**Ref: ABP-319566-24**

**App: Shannon LNG Limited**

**For:** The proposed development will consist of the following components: • Three (3 No.) blocks of Combined Cycle Gas Turbines (CCGT), each block with a capacity of approximately 200 megawatts (MW) for a total installed capacity of up to 600 MW. • A 120 MWh (1-hr) Battery Energy Storage System (BESS). • Above Ground Installation (AGI) compound. • High voltage 220 kV Gas Insulated (GIS) Substation. • Auxiliary Boiler. • Raw water treatment and storage. • Structural / Architectural Buildings (various). • Sewerage drainage system. • Process effluent collection system and sump. • Firewater storage tanks and fire water pumps. • Ancillary buildings. • Secondary Fuel Offloading storage.

**Site:** Kilcolgan Lower and Ralappane, between Tarbert and Ballylongford, Co. Kerry and on the Shannon Estuary

*Site Area from Light Pollution Map*

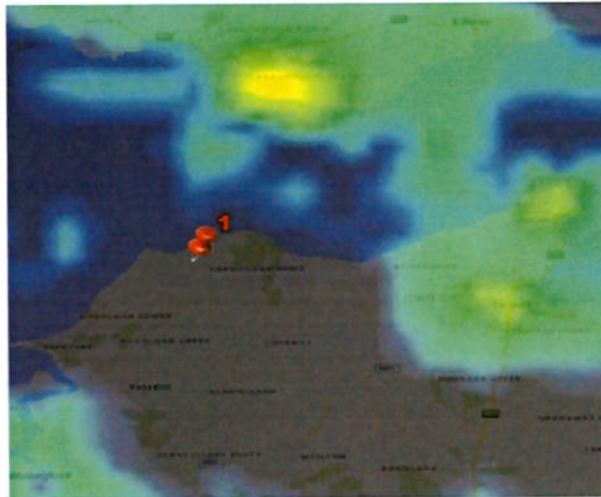
We would also highlight the existing areas in the region containing sources of high emitting light, which we submit could be exacerbated by the proposed development. This would lead to the

extension of the light pollution area into the site occupied by the subject proposal, an area which currently is devoid of a high light emitting source, as demonstrated below by a screenshot from a light pollution map which is frequently utilised by Dark Sky Ireland.<sup>8</sup> The effect of this would be to intensify light pollution cumulatively with existing sources to the north and east of the subject site, with consequent impacts upon human health, insects and other species residing in the water. For example, ecological light pollution effects are known to induce changes in circadian rhythms, interference with orientation and migration patterns, alterations of predator-prey interactions and other behavioural and physiological effects.<sup>9</sup>
